Application for Works Approval Amendment

Works Approval Number	W6907/2024/1
Works Approval Holder	Premier Metals Corporation Pty Ltd
ACN	635 161 992
File Number	APP-0031222
Premises	<p>Premier Metal Recyclers 87 and 89 Kelvin Road Maddington WA 6109</p> <p>Legal description – Lot 25 on Diagram 90351 Certificate of Title Volume 2062 Folio 394 and; Lot 201 on Deposited Plan 30719 Certificate of Title Volume 1159 Folio 415 As defined by the coordinates in Schedule 1 of the Revised Works Approval</p>
Date of Report	15 December 2025
Decision	Revised works approval granted

This Amendment Report documents the assessment of potential risks to the environment and public health from proposed changes to the emissions and discharges during the construction and operation of the Premises. As a result of this assessment, Revised Works Approval W6907/2024/1 has been granted.

Figure 1: Distance to sensitive receptors

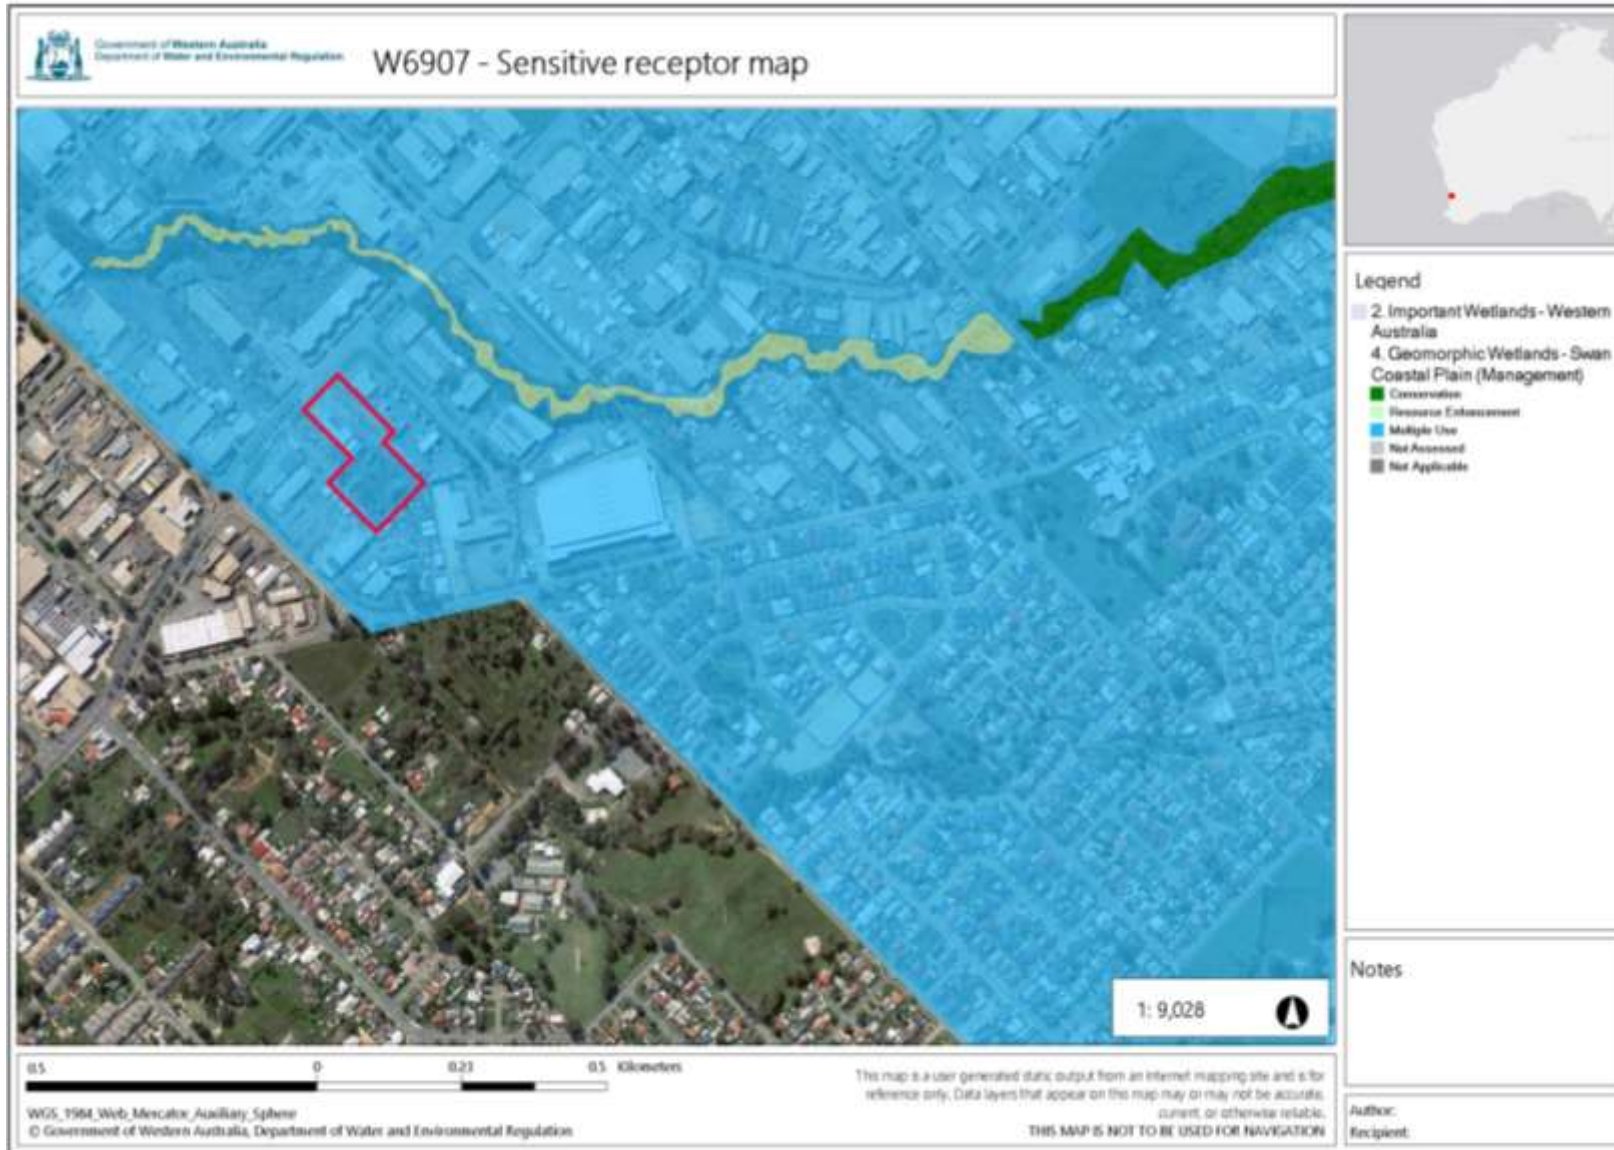
Table 2 below provides a summary of potential human and environmental receptors that may be impacted as a result of activities upon or emission and discharges from the prescribed premises (*Guideline: Environmental siting* (DWER 2020)).

Human receptors	Distance from prescribed activity
Residential Premises	150 m south of the premises boundary 200 m southeast of the premises boundary 600 m northwest of the premises boundary
Industrial premises	Immediately adjacent to the premises are other industrial premises
Environmental receptors	Distance from prescribed activity
Brixton Street Swamps	1.6 km northeast of the premises boundary
Geomorphic wetlands	Premises located within a geomorphic palusplain Canning River palusplain located 1.6 km southwest of the premises boundary
Bickley Brook (drains into the Canning River) - Resource enhancement wetland	150 m northeast of the premises boundary
Proclaimed area (RIWI Act 1911) – Perth Groundwater Area	Premised located within the proclaimed Perth Groundwater Area
Priority and Threatened Ecological Communities (PEC/TECs)	P3 – Priority ecological community is located 800 m east of the premises boundary
